## City of Laramie

# MEMORANDUM

**Subject:** Major Street Plan Map – Modification Considerations

**Request #1 - "Consideration of removal from the Major Street Plan those streets mapped from the intersection of 45th and Crow to the east end of Willett and to the north end of Boulder Drive.":**

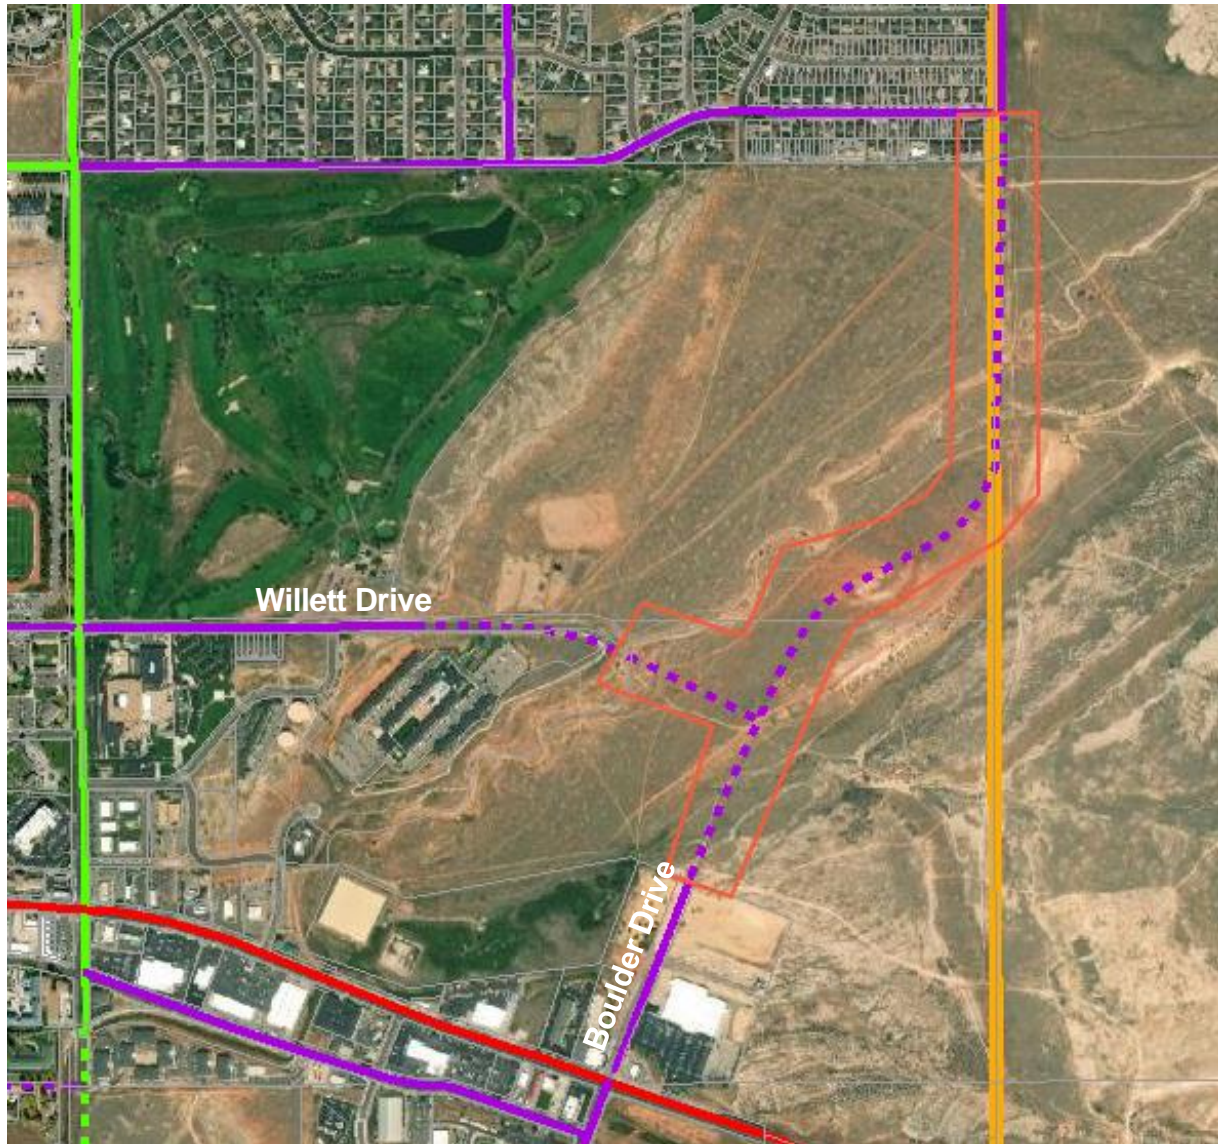
"Through review of the proposed Growth Area Management Plan and updated Casper Aquifer Protection Plan - two ongoing City/County cooperative projects - it has come to my attention that the City's Comprehensive Plan includes a "Major Street Plan" that presents a small network of streets in the area between 45th Street and Grand Ave. In the posted Laramie Comprehensive Plan, this "Map 8.1" shows a "parkway" (only one step below an "Interstate") running from the corner of 45th and Crow, south to join Grand Ave. at Vista Drive. In a subsequent, freestanding posting dated 2018, the map has downgraded the concept somewhat, showing "Future Collectors" joining 45th & Crow with the east end of Willett and with the north end of Boulder Drive.

In either case, the concept of major streets running through this area is contradictory to the guidance of the Casper Aquifer Protection Plan, which recommends minimal development in the Casper Aquifer Protection Area, and is inconsistent with the substantial and continuing investment of the city, county, state, and various community groups in the preservation and

To faithfully reflect community plans and aspirations for the future of this area, I suggest you remove these street segments from the relevant maps and plans. Nobody reading your planning documents should be led to believe that the city is planning to build city streets through this area, nor should such streets be on any prioritization list for future funding.

In general, as depicted in the reasoning above, the consideration of this change is related to ongoing planning processes occurring between the City and County as well as limited expected development in the area, thus not warranting the need for these roads on the Major Street Plan. The consideration if adopted would remove these roads from the Major Street Plan as depicted in the map below.

The City of Laramie related to this request would not recommend that this change be considered, and that these proposed roads remain on the Major Street Plan as depicted. Despite the fact that planning efforts in this area anticipate limited growth and identify factors such as aquifer protection as reasons not to grow in the area, it does not negate the fact that these roads will still serve a broader transportation purpose for the existing developments in the Alta Vista and Indian Hills neighborhoods as well as future anticipated growth to the north of the City and for the community as a whole.

Currently existing neighborhoods in this area must access 30<sup>th</sup> Street, a minor arterial to travel north or south within the community. With more growth anticipated in the areas north of the city as shown in the current City of Laramie Comprehensive Plan as well as the current draft of the Laramie Area Growth Plan, eliminating possible transportation corridors in this area is not desired by the City at this time. The City anticipates major growth north of the City based upon major infrastructure improvements being made to water and sewer in the area that will provide opportunity for growth north of the City. These roads may still be needed from a transportation network standpoint and thus the city desires not to have them removed.

**Request #2 - “Extension of Inca Drive to the northern most proposed Collector shown on the Major Street Plan.”:**

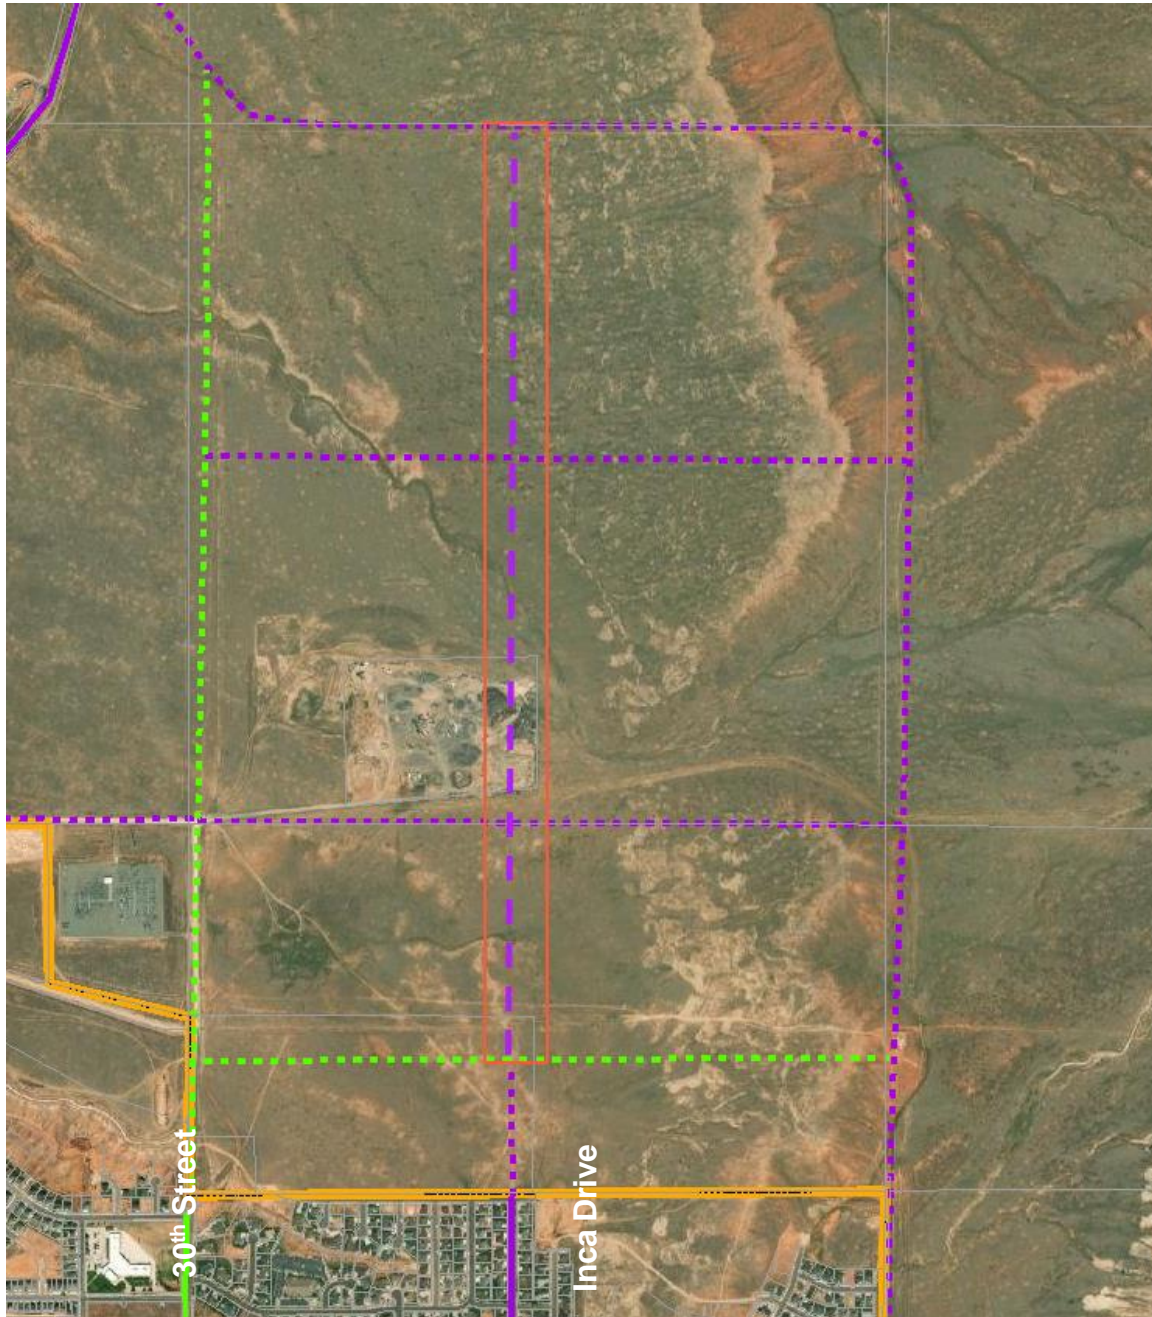
With anticipated growth likely to occur north of the city, including a large subdivision nearing submittal, and due to infrastructure improvements being made in the area to both water and sewer, the extension of Inca Drive has been identified as a needed addition to the Major Street Plan. Currently Inca Drive extends north, just outside of the City limits, stopping at the future east-west proposed collector (Cumulus Drive). The City of Laramie is requesting that Inca Drive be extended to the most northern proposed collector as shown in the Major Street Plan and as shown in the map below. This extension will facilitate a more grid like pattern with better spacing between other proposed collectors and will provide future access to 30<sup>th</sup> Street and 45<sup>th</sup> Street as growth continues

northerly. The City of Laramie requests that this addition be made to the Major Street plan as shown in the map below.

Albany County Planning Department supports this recommendation.
